#### Final Plat

#### Construction Plans

1. Static Head  Feet

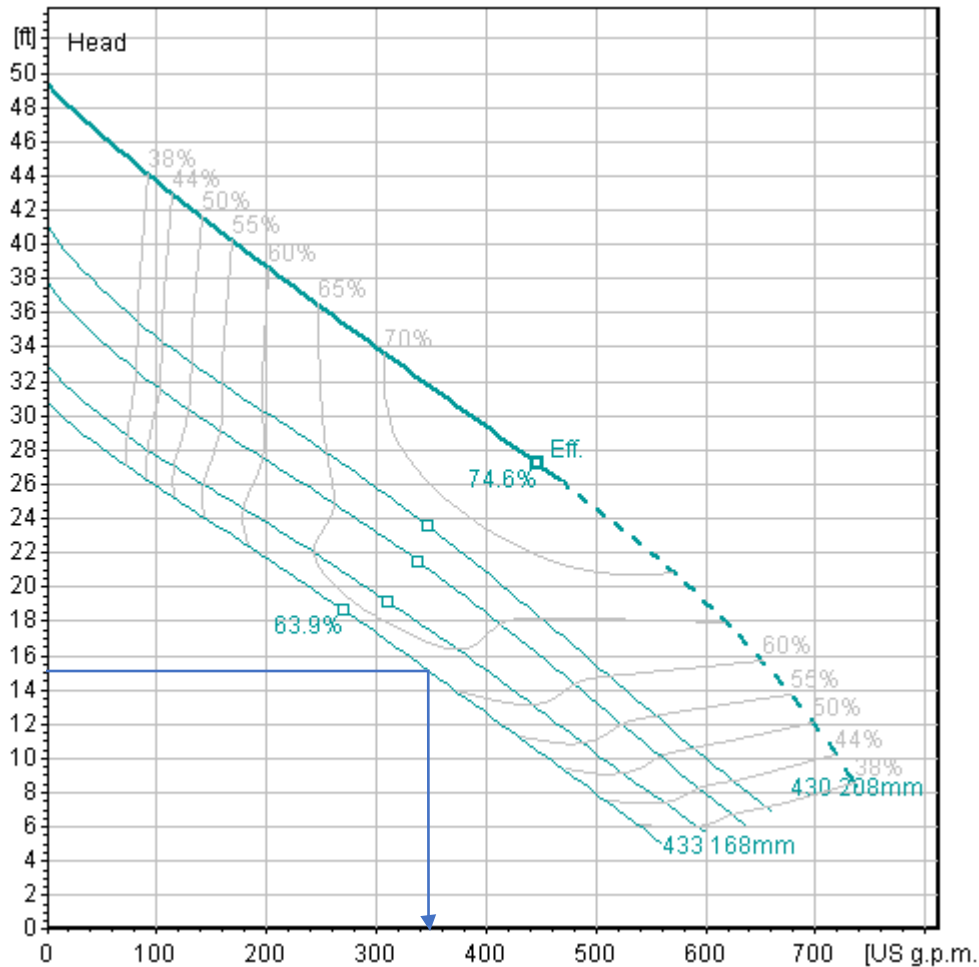
2. Verification to be provided for existing lift station capacity for this section and to notate any modifications required for pump operation at lift station.

**SEE PAGE 20 AND 21 OF THE HERITAGE PART SECTION 1 AS BUILT. THE LIFTSTATION USED TWO CP-3102 FLYGT PUMPS. THE LIFT STATION CURRENTLY OPERATES ON 3 PHASE POWER, AND PUMPS SEWAGE TO THE MANHOLE LOCATED AT HENDERSON AND DOWLING VIA A 4" FORCE MAIN.**

**THE PUMPS OPERATE ON LEAD LAG AND UNDER A TOTAL HEAD PRESSURE OF 15.0 FT. THE PUMP IS RATED FOR A TOTAL CAPACITY OF 350 GPM, WHICH EXCEEDS THE PEAK DEMAND FROM SECTION 1-3 (90 HOMES – Q<sub>p</sub>= 74 GPM).**
